CITY OF NEW ALBANY, FRANKLIN COUNTY, OHIO
FINAL DEVELOPMENT PLAN
FOR
THE COURTYARDS AT HAINES CREEK
FIRE TRUCK TURNING MOVEMENTS

Subject: Courtyards at Haines Creek
Review Response Letter #2

Items from Planning Commission Staff Report – October 16, 2023:

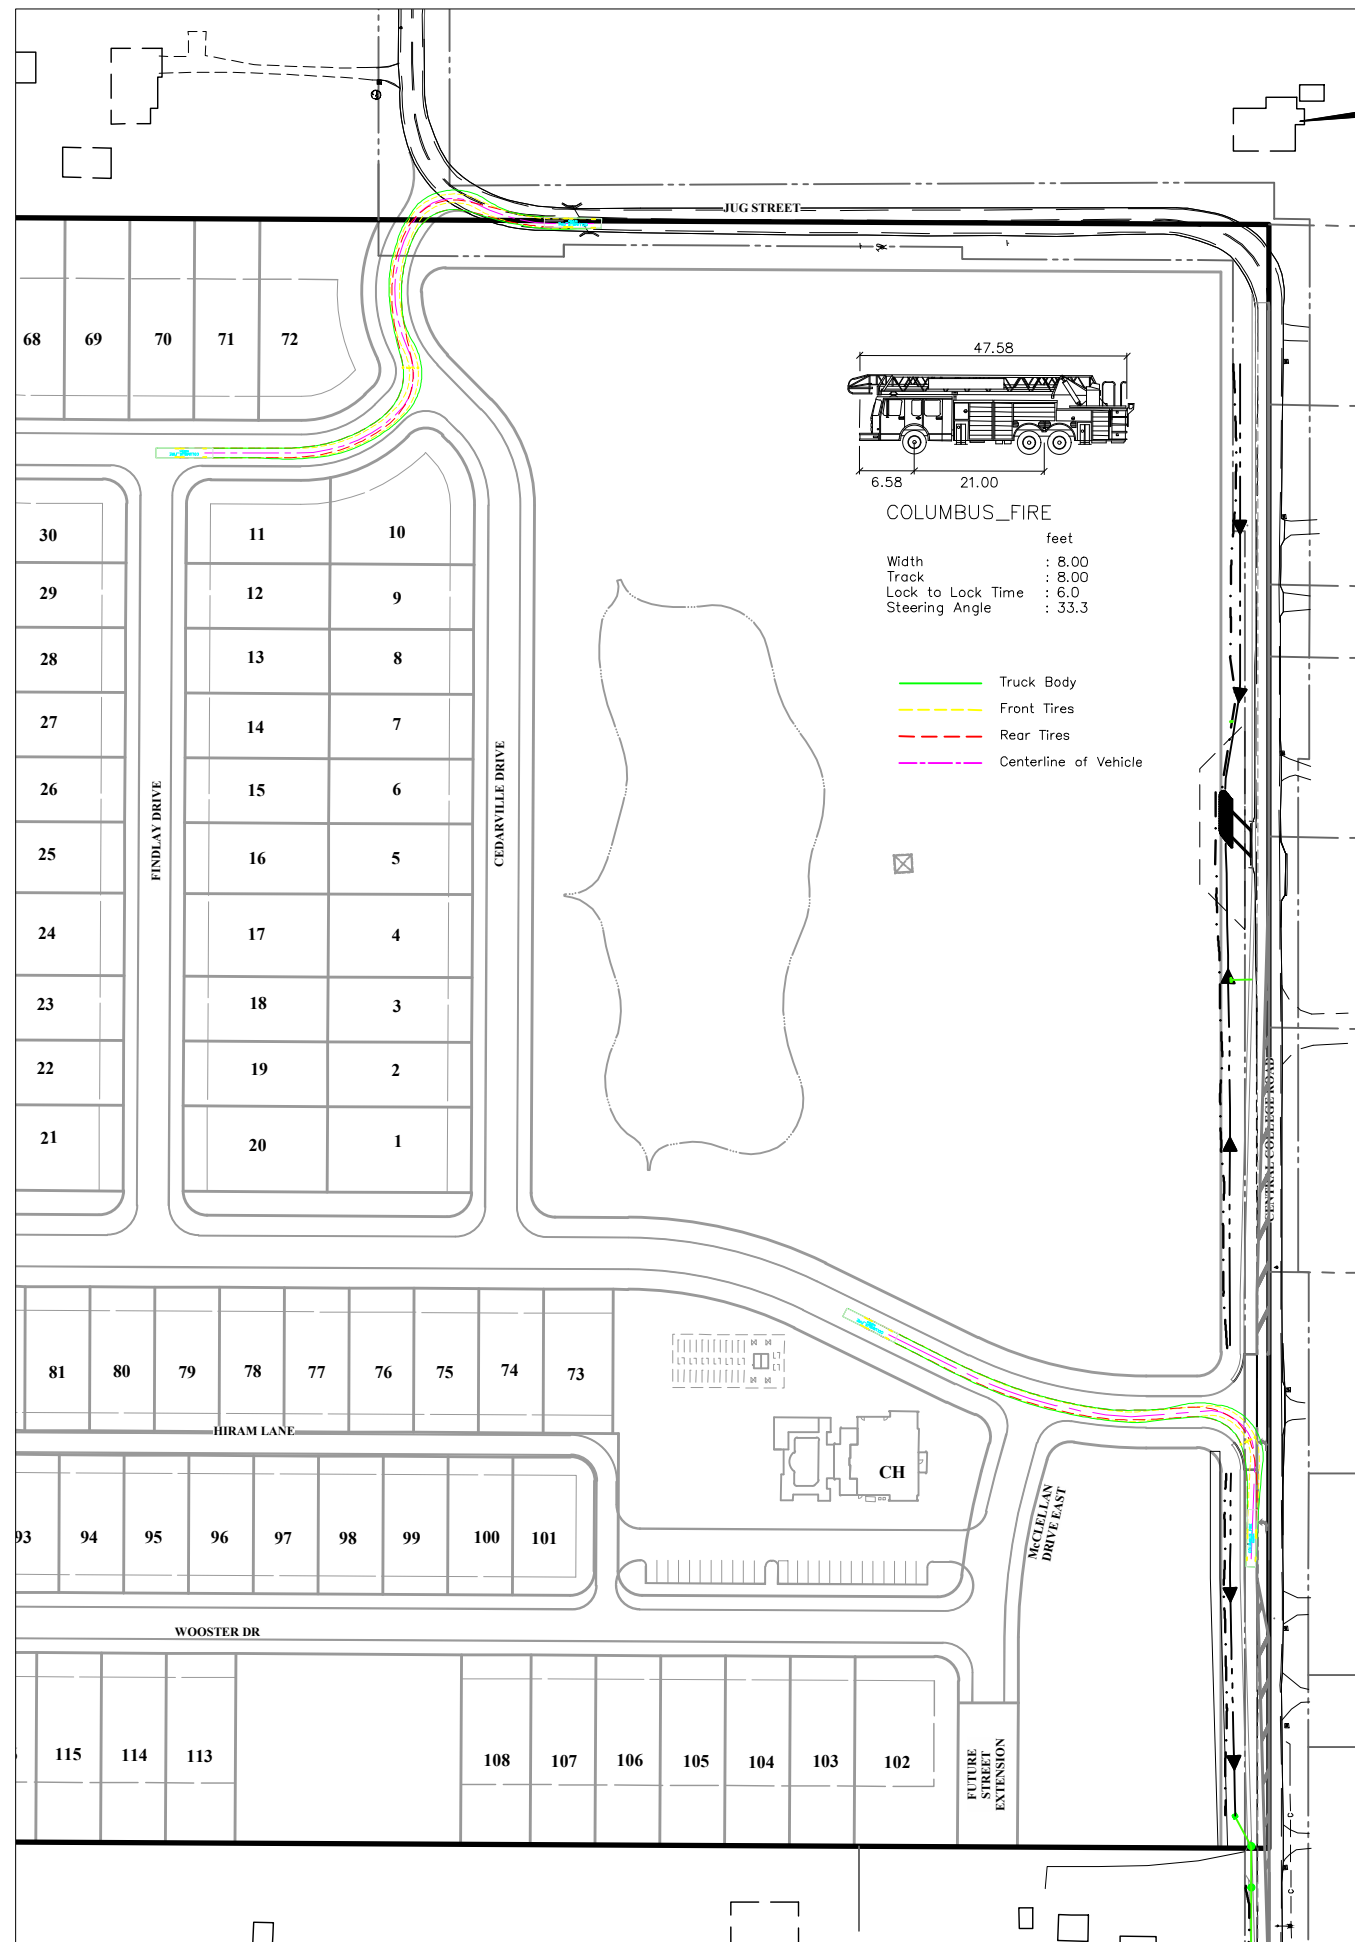
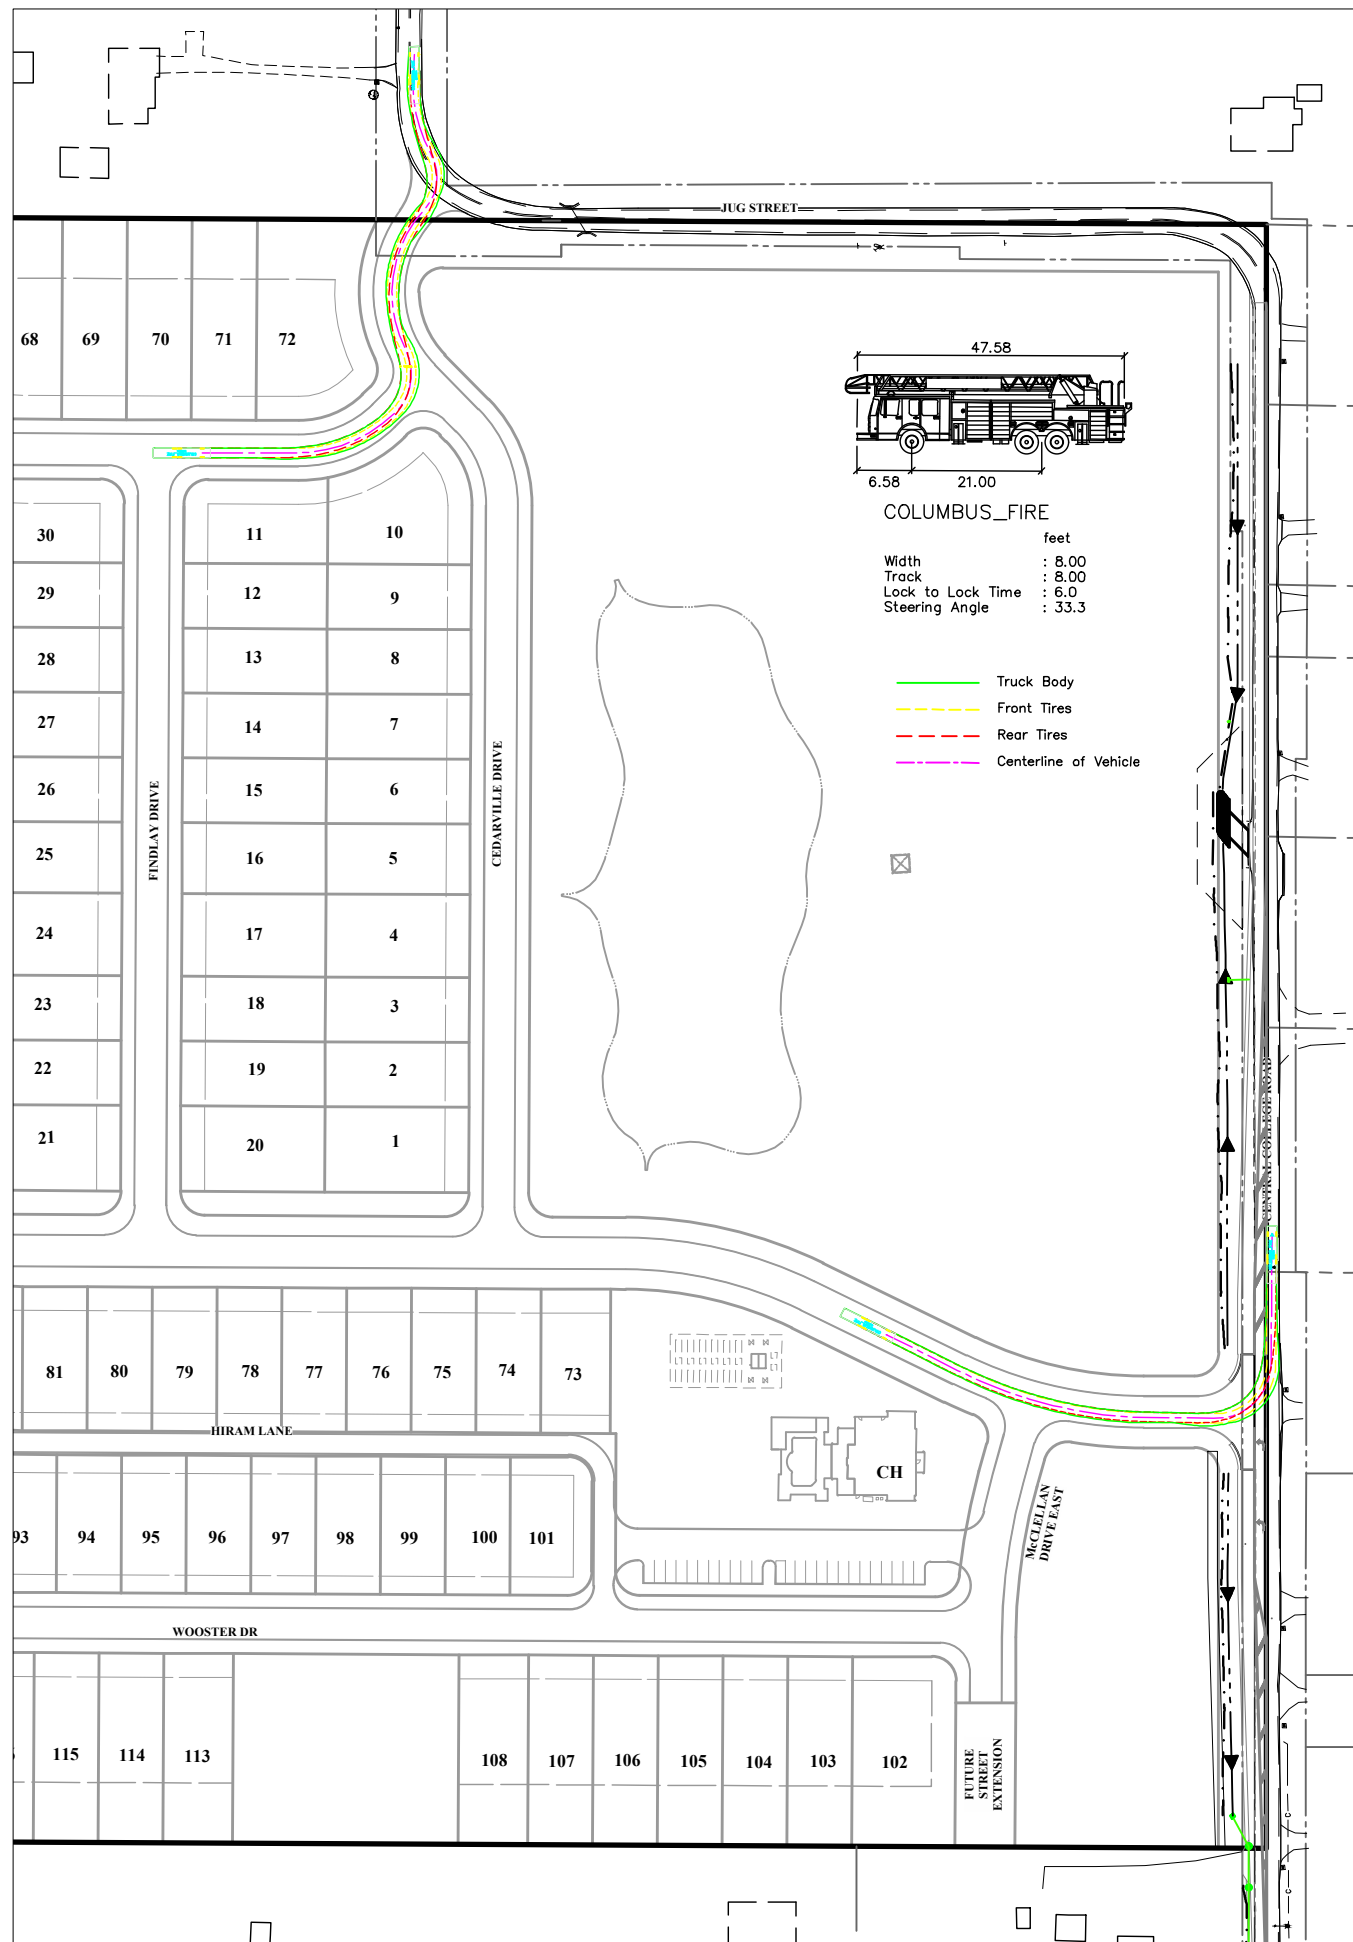
9. Provide Fire Truck turning radius analysis.

Response: *AutoTurn exhibit has been included as a separate exhibit for reference. See Section I of Submittal Materials per table of contents.*

LOTS 102-124 - TYPICAL GRADING SECTION

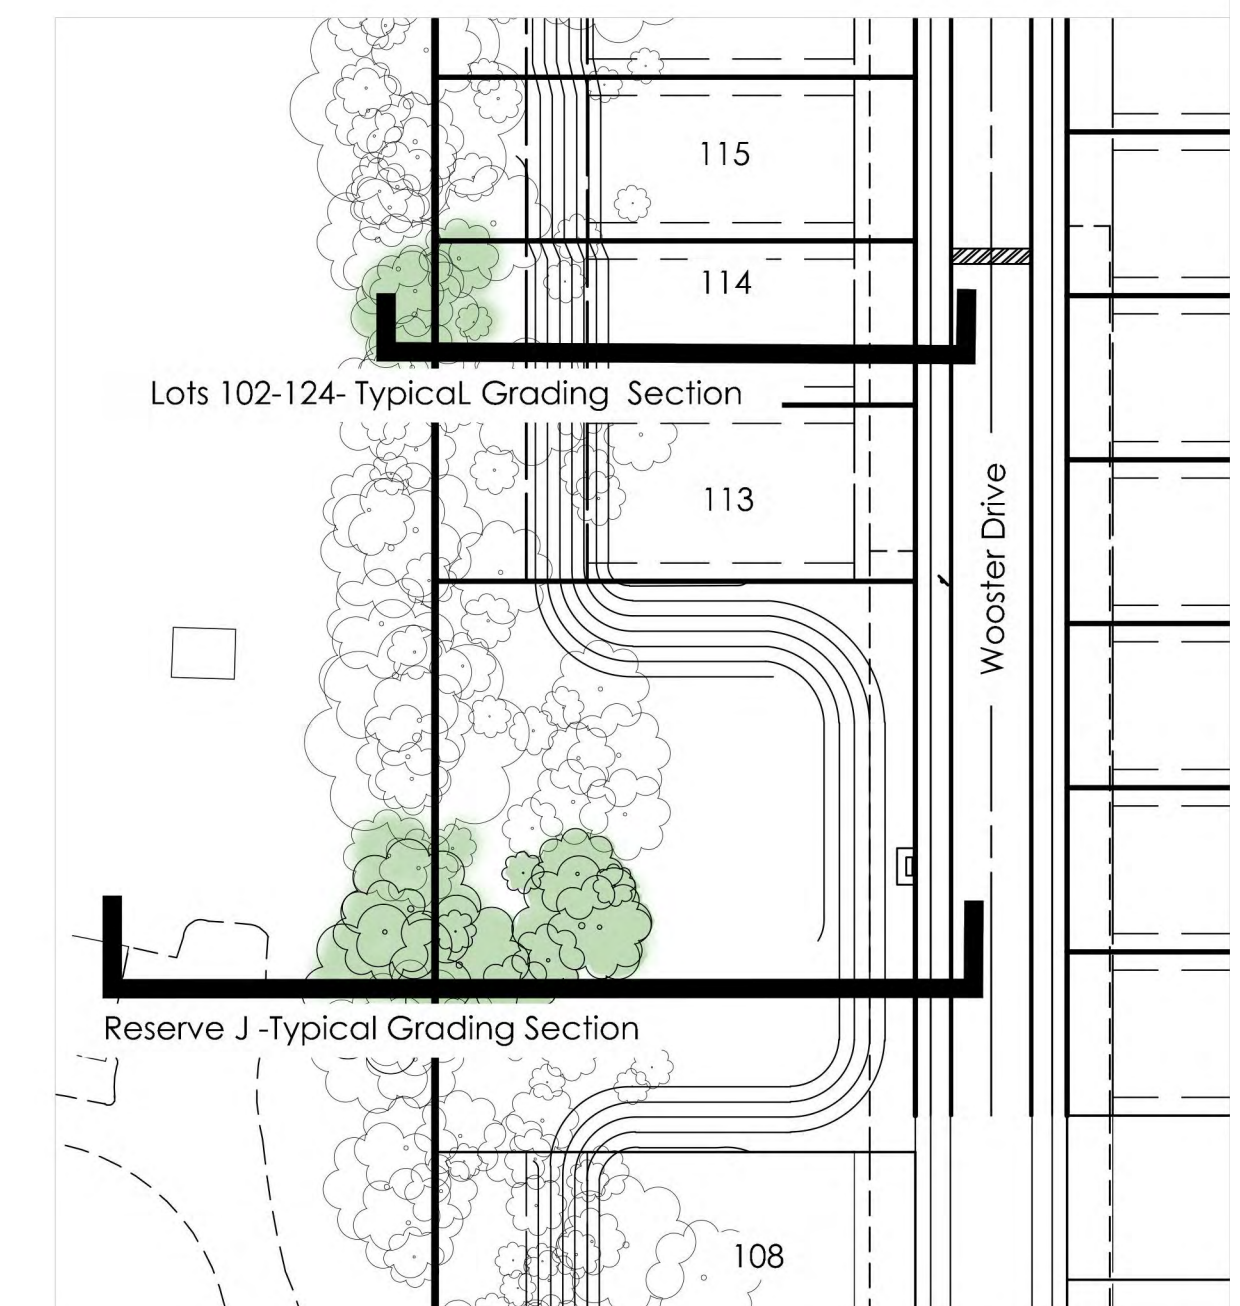
2. Please provide sections that were previously requested.

- i. Previous EMH&T response: We will provide this with the FDP submission.
- ii. **Status: Complete.** EMH&T submitted one section. They appear acceptable but the city recommends that the 4:1 slope be planted with meadow grass. The city also recommends undulating the mounds where possible and around large tree bases to provide a more natural aesthetic. This can be included in the updated FDP submittal.

5. Your last submittal showed gravel as opposed to grass in the rear of the homes. Staff had asked for this to be revised. The resubmittal should show this – perhaps on the sections mentioned above.

Current EMH&T Response: Section has been updated with meadow grass extending up the slope. Buffer plan has been updated with undulating mounds where possible.

Current EMH&T Response: Section has been updated with meadow grass extending up the slope.

Main Entry Sign at Central College
Road and Jug Street Entries
Not to Scale

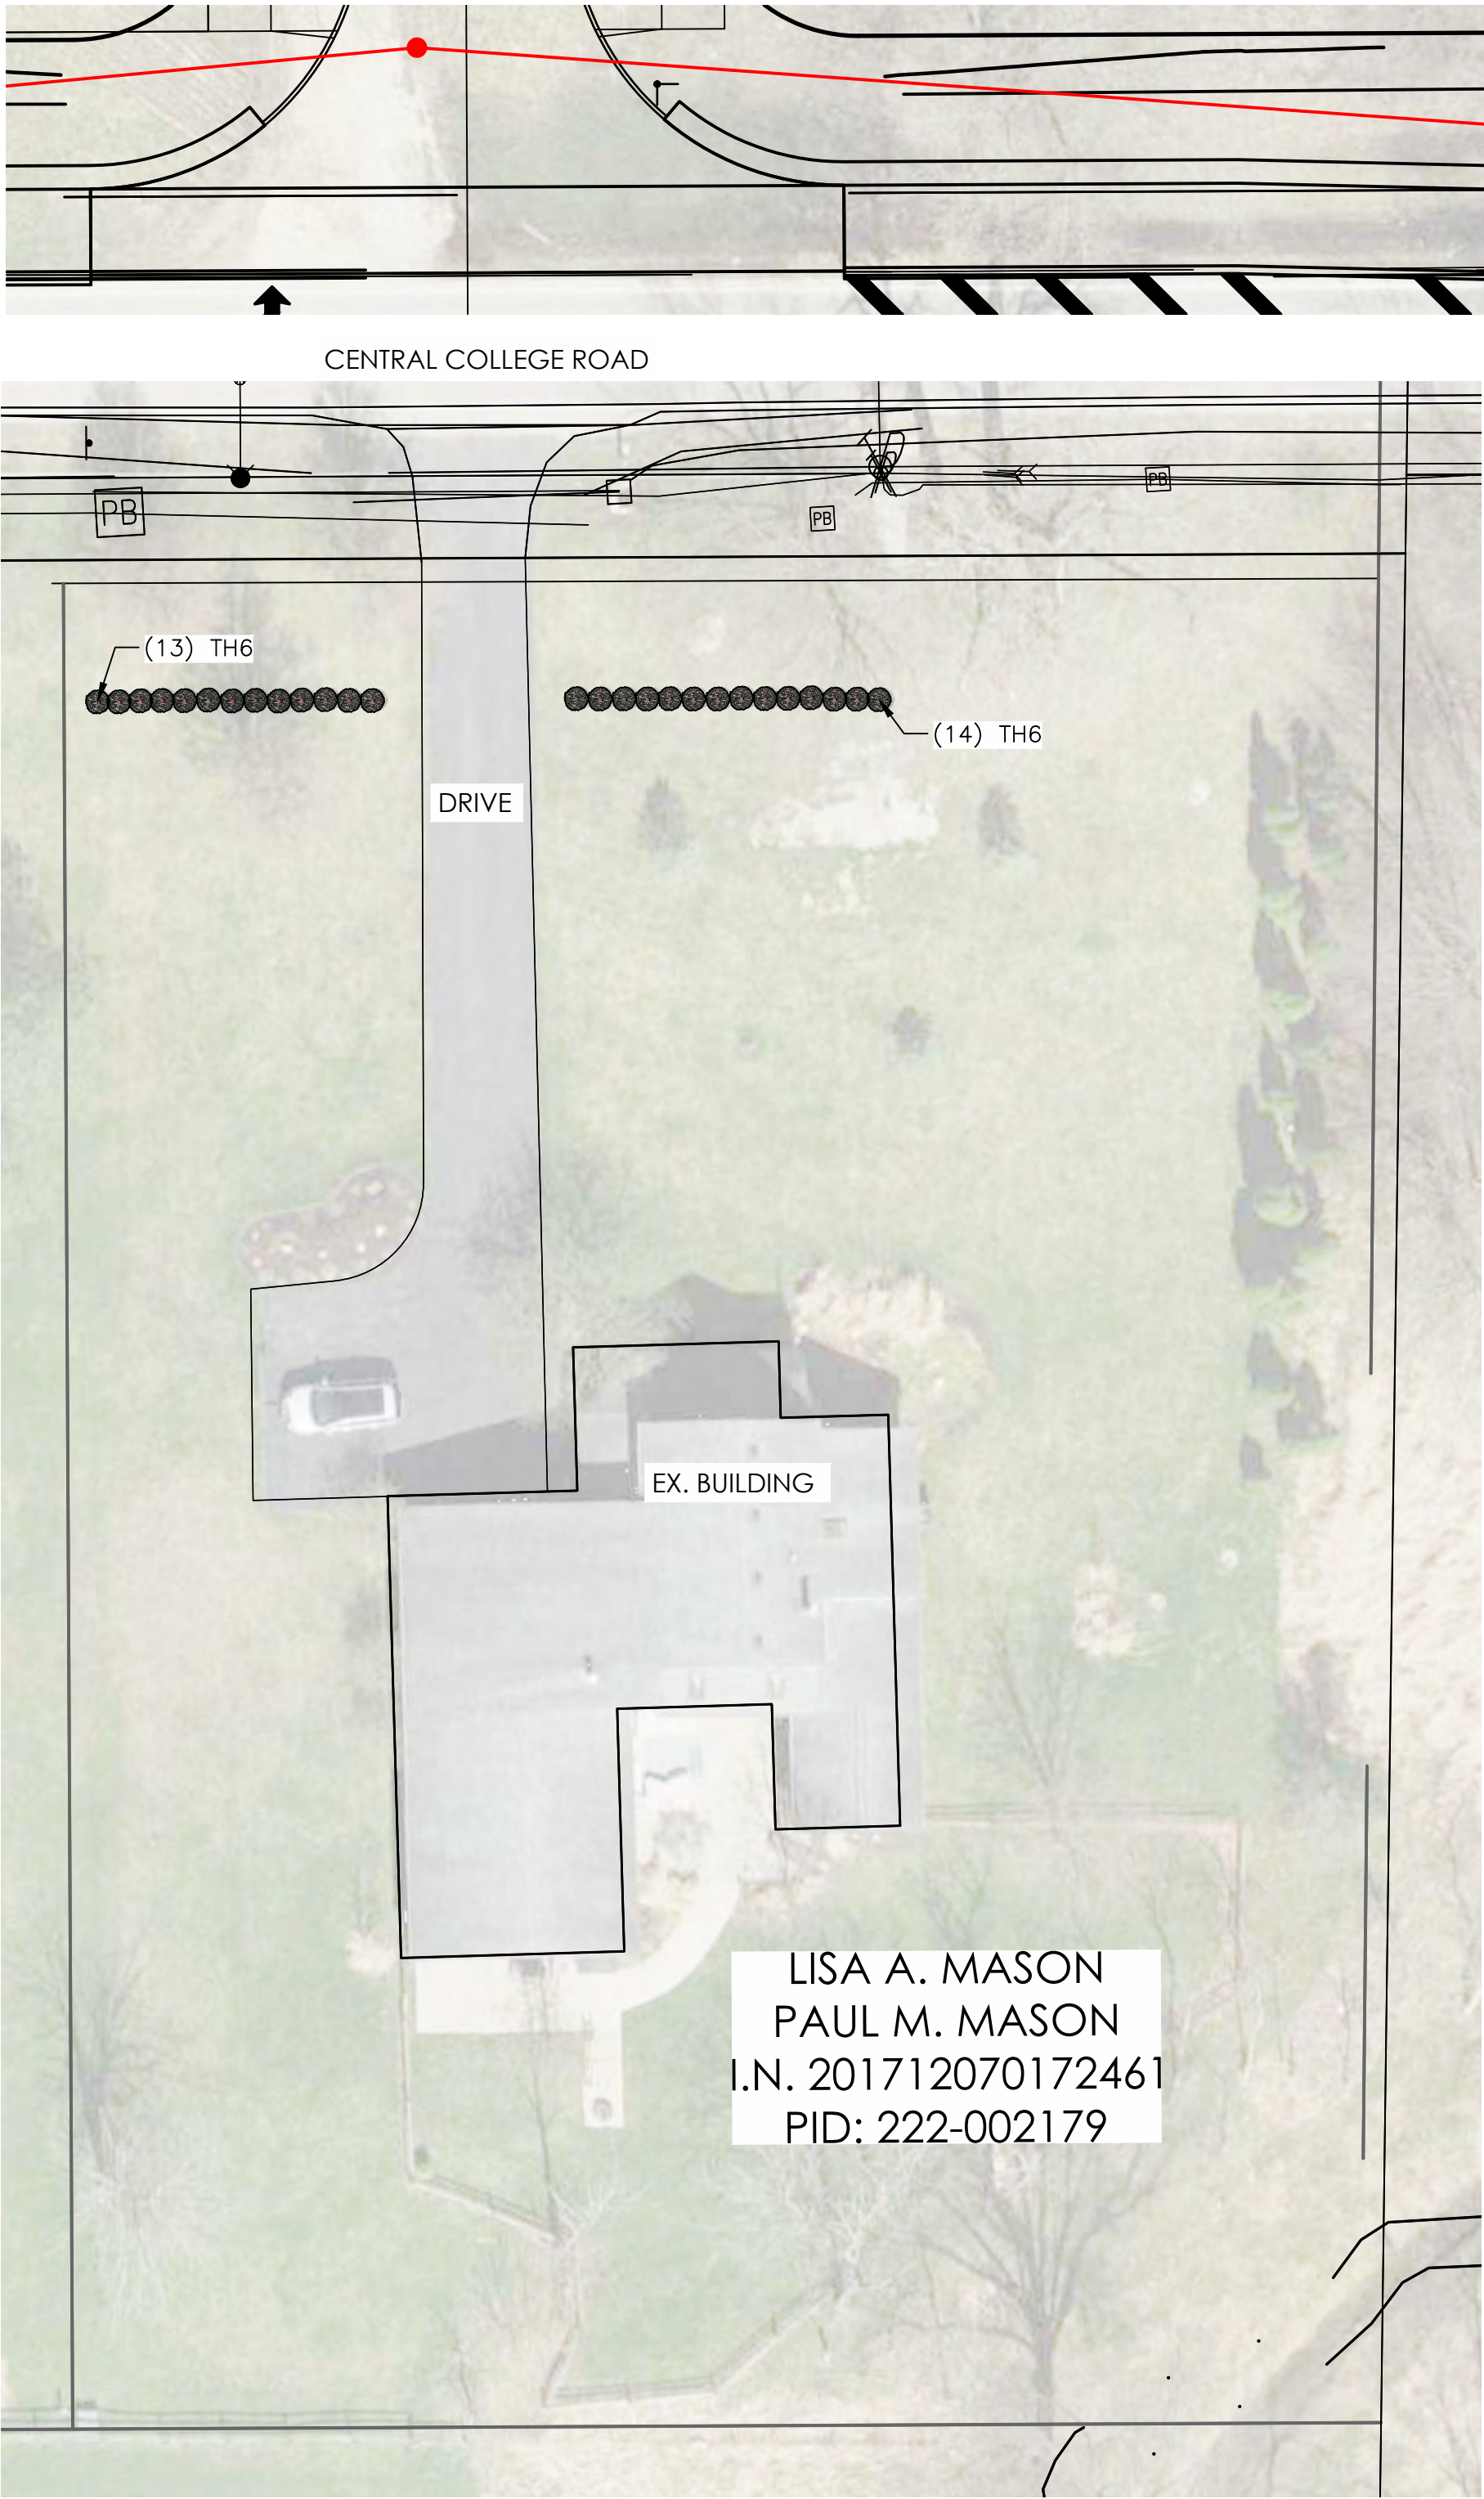
- v. Revise entry sign at Central College Road to match precedents in the neighborhood, see images for reference.

Response: *The design of the entry signs along Central College will match the previously approved signs at the Courtyards at New Albany as provided in the FDP.*
